Office Action Summary

10/586,972

DETAILED ACTION

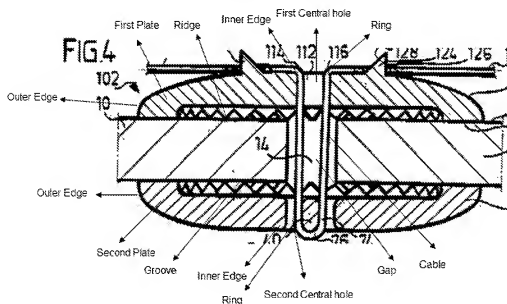
Regarding **Claim 1**, Nesper discloses a fixing device (as seen in Fig below) comprising:

a surgical cable having a first and a second end and (see fig below and paragraph 55)

at least a first and a second fixing plate each having a first and second central hole respectfully (as seen in Fig below and paragraph 47) and

a first and second ring surrounding said first and second hole respectfully (as seen in Fig below and paragraph 71),

the circumference of each fixing plate forming an outer edge of its ring and an inner edge of its ring being adjacent to the hole it surrounds (as seen in Fig below and ,

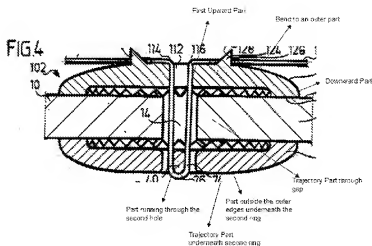
the first fixing plate being in a stacked position on top of the second plate leaving a gap between the plates and the holes at least partly overlapping each other (as seen in Fig below),

wherein in the ring of one of the fixing plates in its surface facing the other fixing plate a continuous groove is present running between the outer edge and the inner edge of said ring and in the ring of the other fixing plate in its surface facing the one of the fixing plates a ridge is present matching with said groove (as seen in Fig below and paragraph 51), and

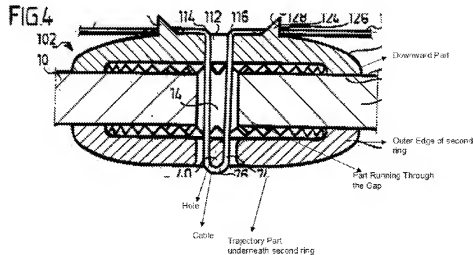
Regarding **Claim 2**, Nesper discloses wherein part further runs outside the outer edge of the second ring and is connected to one end of part through trajectory part running underneath the second ring from its outer edge to its hole and the other end of part is immediately connected to part running through the gap between the fixing plates in an outward direction and ending outside the plates in a cable end (see Fig below and above in claim 1 and the examiner notes that one can place the cable in any number of configurations such as that listed above and in claim 1, if one chooses to do so).

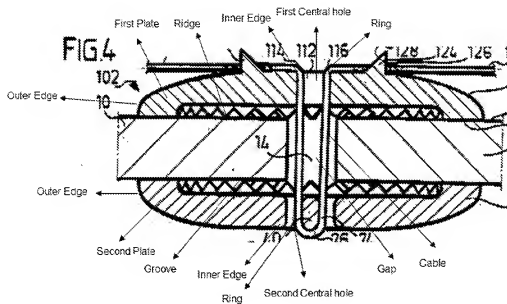
Regarding **Claim 3**, Nesper discloses wherein the trajectory parts are in the order (a), (b), (c), (e), (d), followed by trajectory part running underneath the second ring from the hole to the outer edge and ending outside the plates in a cable end (see Fig above in claim 1 and claim 2, the examiner notes that one can place the cable in any number of configurations such as that listed above and in claim 1, if one chooses to do so).
